UNITARY PLAN UPDATE REQUEST MEMORANDUM

TO Warren MacLennan, Manager Planning North West and Islands
FROM Jo Hart, Principal Planner, Planning North West and Islands
DATE 18 October 2019
SUBJECT **Designation in accordance with s168 of the Resource Management Act of the Auckland Unitary Plan(AUP) Operative in part (15 November 2016)**

CONSENT ORDER

Annexure D – Proposed Temporary Traffic Management Plan (Ref. L1N171201)

PaknSave Access TMP - Lincoln Road Section 2

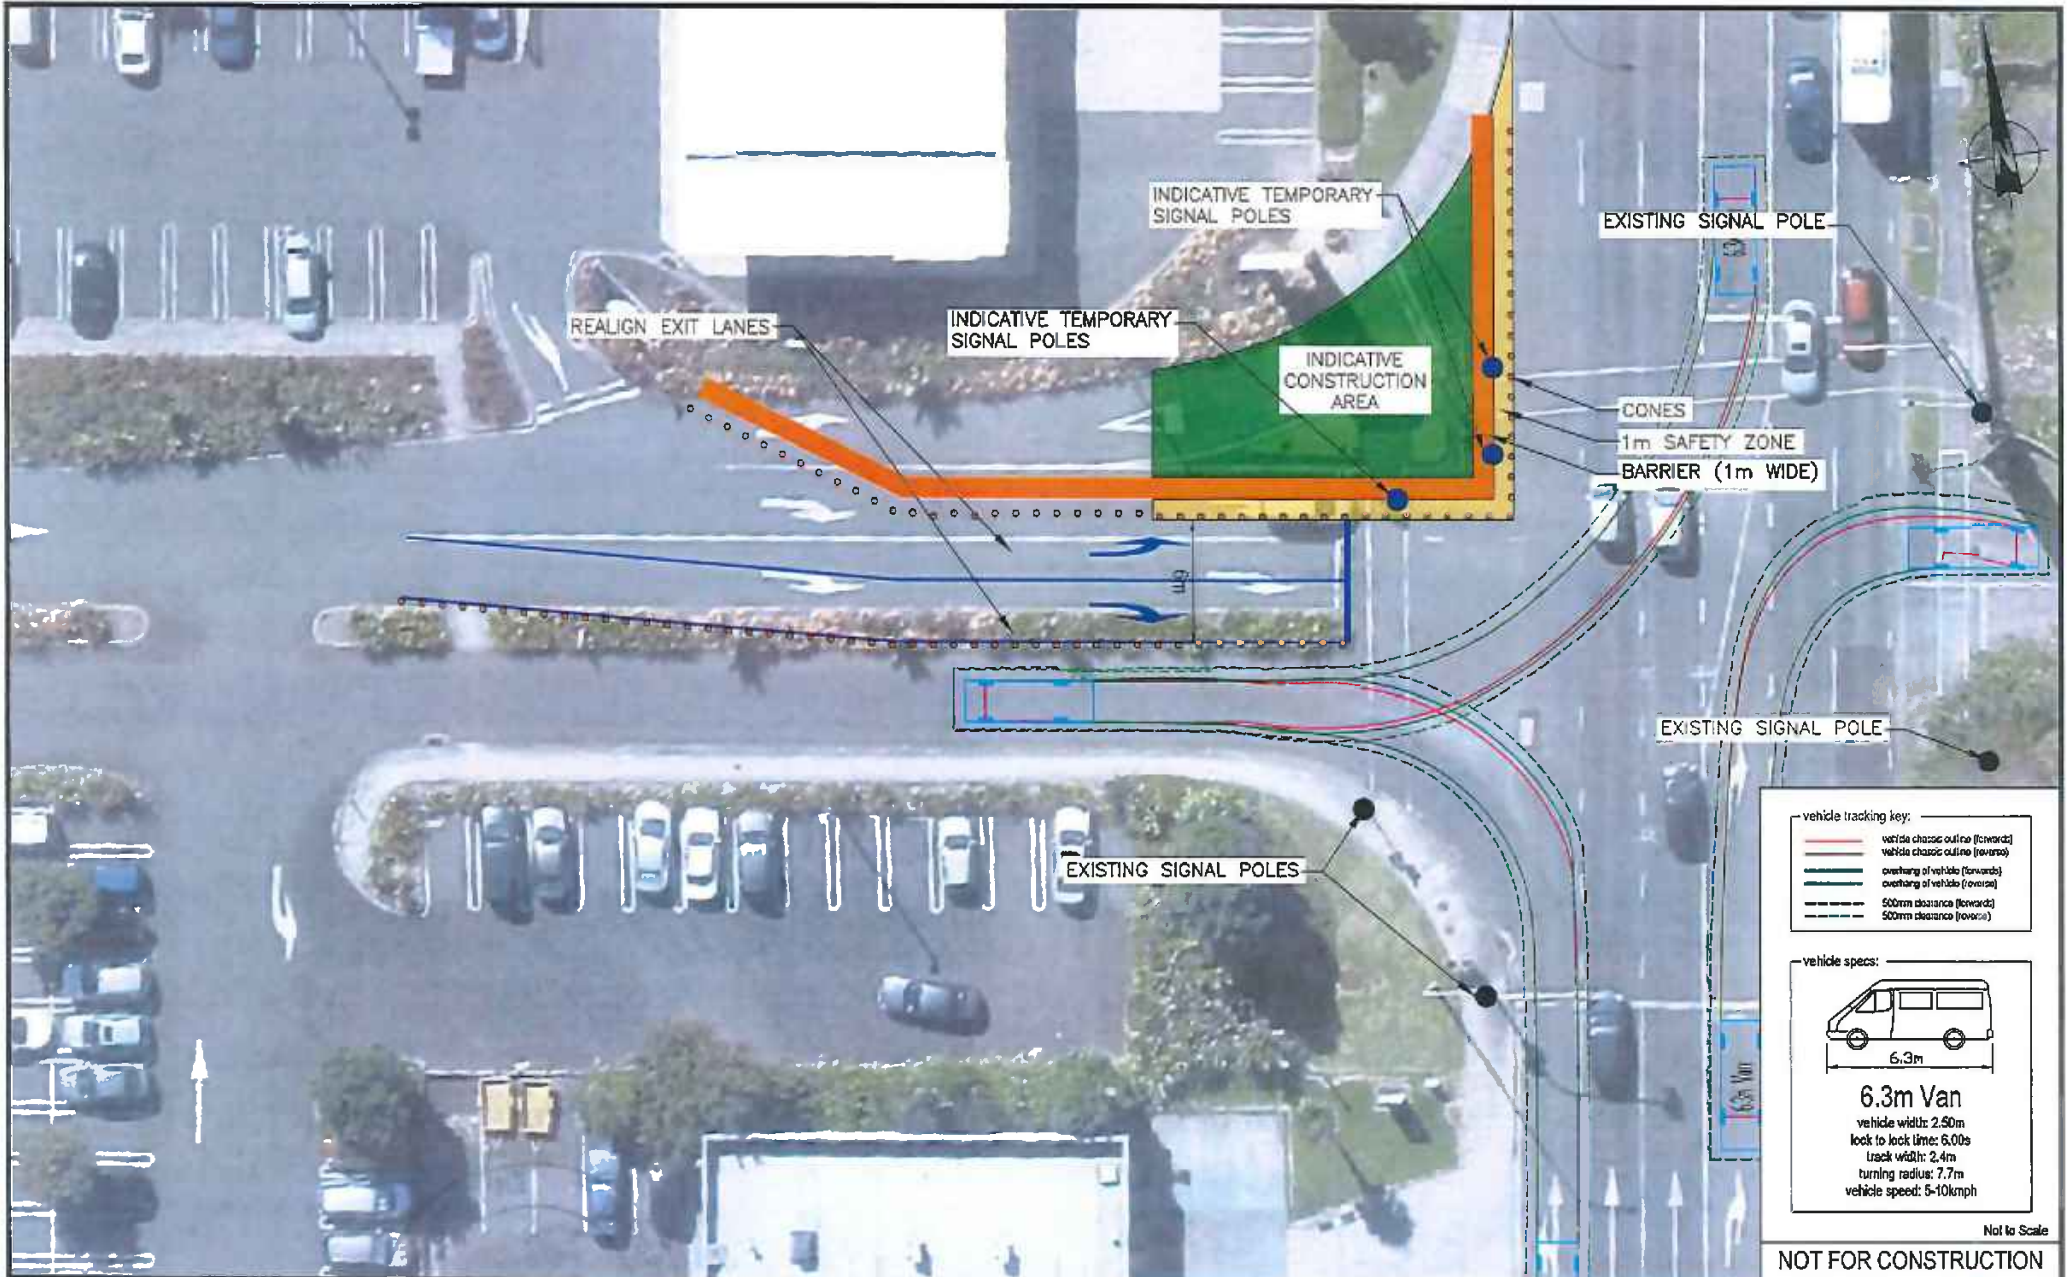
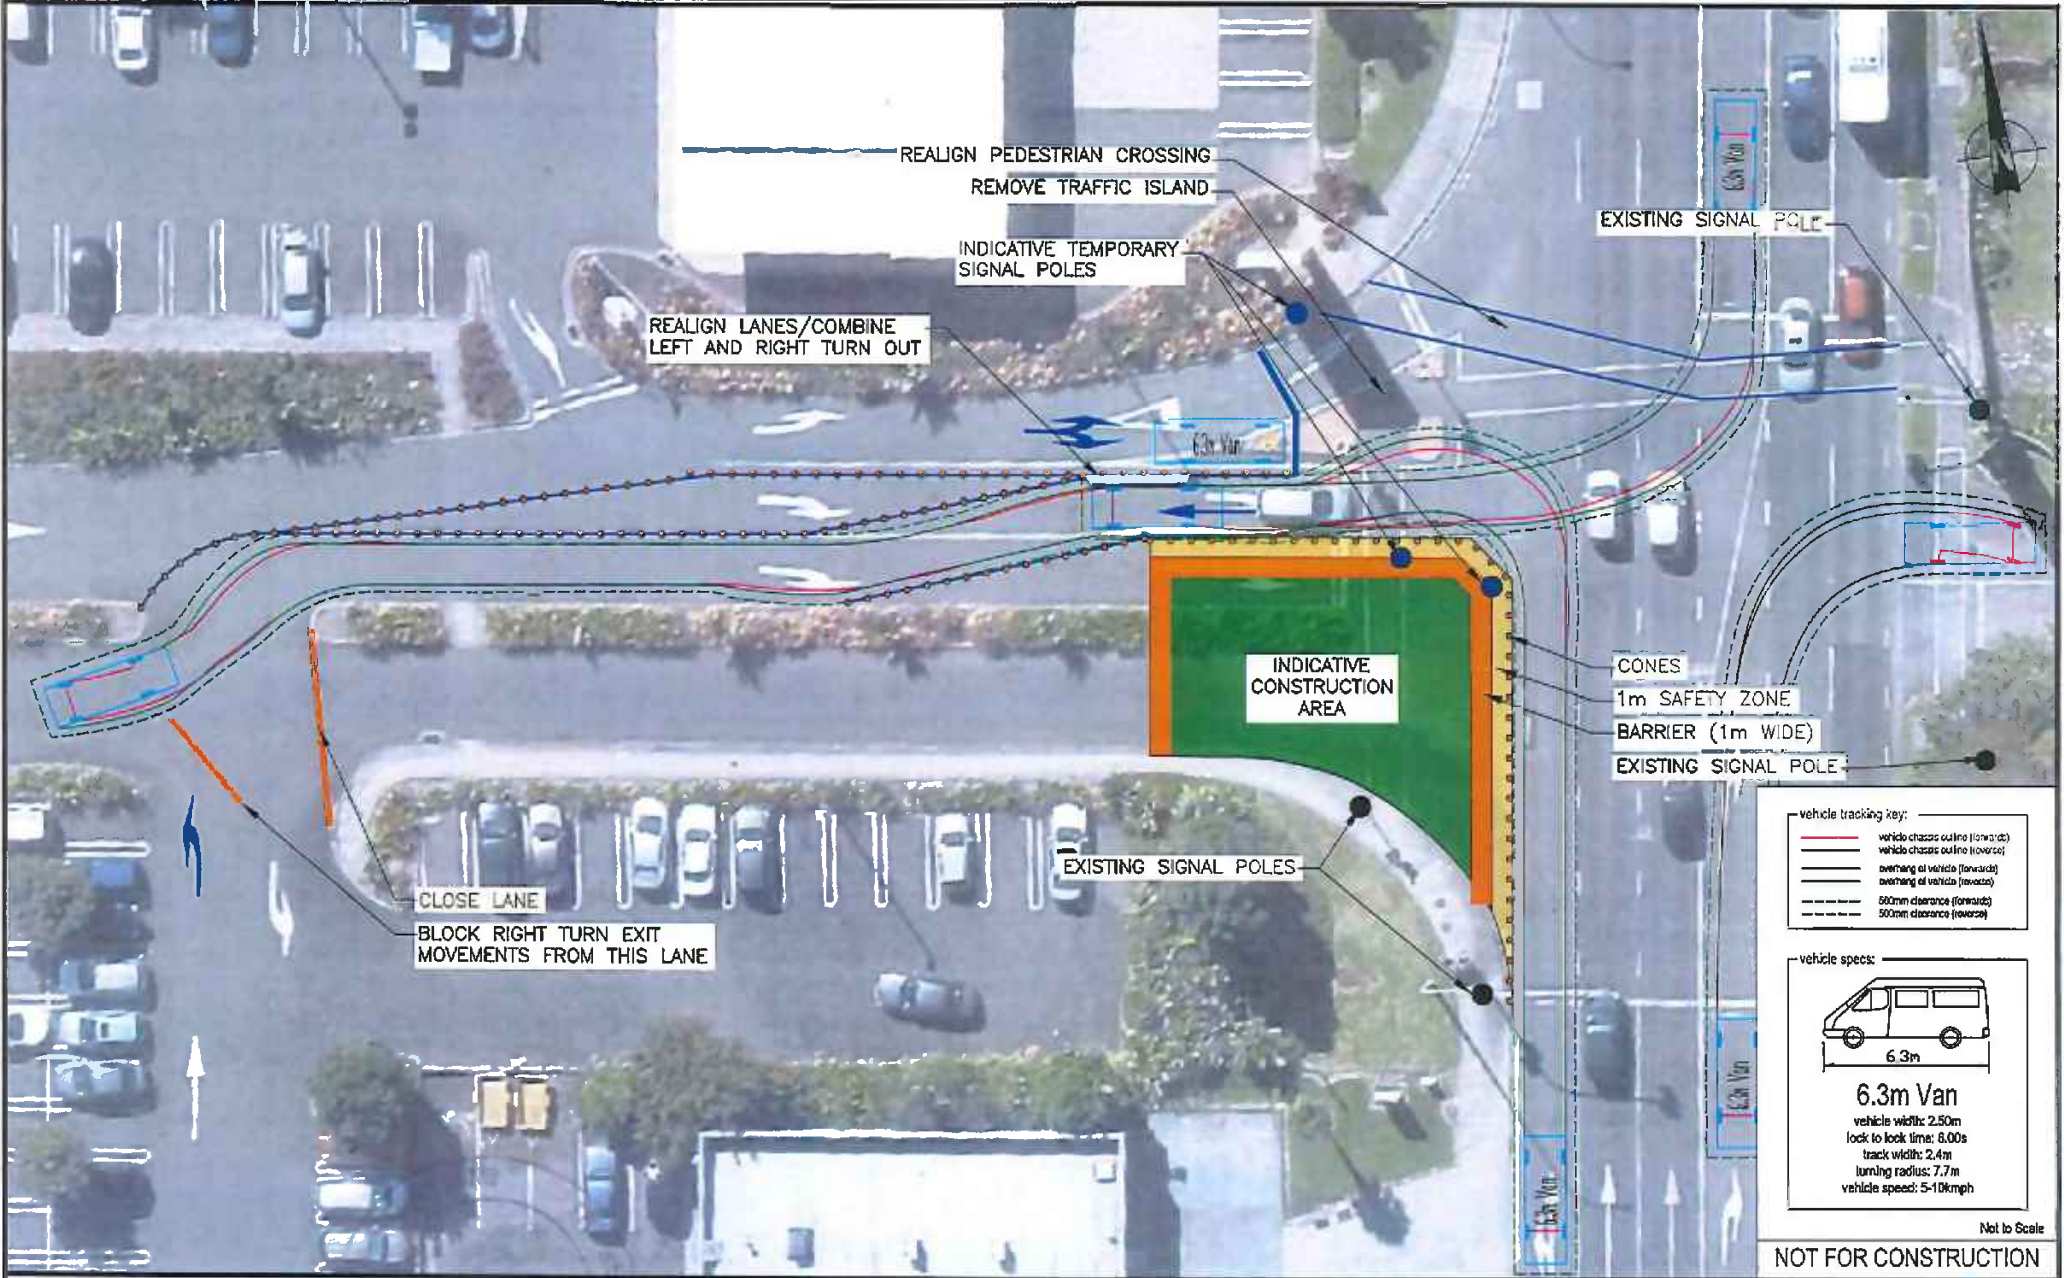
- No pedestrian access provided to the ped across Pak n Save access (Boulevard). Have any alternative arrangements been made?
As above, a pedestrian crossing across the Pak'n Save access will be provided, however the details of this cannot be confirmed until the extent and location of the trenching required is confirmed.

- Tracking not provided for overlapping movements as mentioned above.
The tracking for inbound and outbound movements is shown separately on Sheets 3 and 4. The tracking for the left turn in does not overlap with the right turn out.

- Tracking has not been provided to show if diamond phase can be accommodated safely.
The tracking of a 6.3m van turning right into the Pak'n Save access has been shown on the plans. This does not cross into the right turn bay marking shown. For clarity, a van turning right into the opposite access has been shown on the attached updated plans.

- Signal visibility may be a serious issue with changed layout. The Pak n Save access (Boulevard) approach has no primary display near the limit line, there is no tertiary display for vehicles to follow when moving into the Intersection. This is a serious safety concern. Every approach is required to have at least three displays (Primary, Tertiary, and Secondary). The locations of the lantern displays should be as such they are clearly visible and are not confusing to motorists.
As noted, temporary signals will be provided, including one in the work zone that will provide the primary displays for this movement. Visibility to the existing secondary signal for the right turn out of the Pak'n Save access will be unaffected, with the signal located just to the south of the Laidlow College access. The existing tertiary signal, to the north of the Laidlow College access may be harder to see, depending on what machinery etc is located within the work area. Acknowledging that there is limited opportunity to provide an additional set of signals due to the location of the Laidlow College access, and that this is a temporary situation, the third display could be located in a visible location within the work area, beyond the primary display pole. (It is noted that while the minimum number of signal faces for a given approach is three, AUSTRROADS also states that "the minimum number of signal faces for each right-turn movement is two". In this circumstance, with temporary

- Tracking has not been provided to show if diamond phase can be accommodated safely.
- Signal visibility may be a serious issue with changed layout. The Pak n Save access (Boulevard) approach has no primary display near the limit line, there is no tertiary display for vehicles to follow when moving into the intersection. This is a serious safety concern. Every approach is required to have at least three displays (Primary, Tertiary, and Secondary). The locations of the lantern displays should be as such they are clearly visible and are not confusing to motorists.

traffic management measures providing a slow and aware environment for drivers, it may be acceptable to provide just two sets of signal displays for this right turn movement)
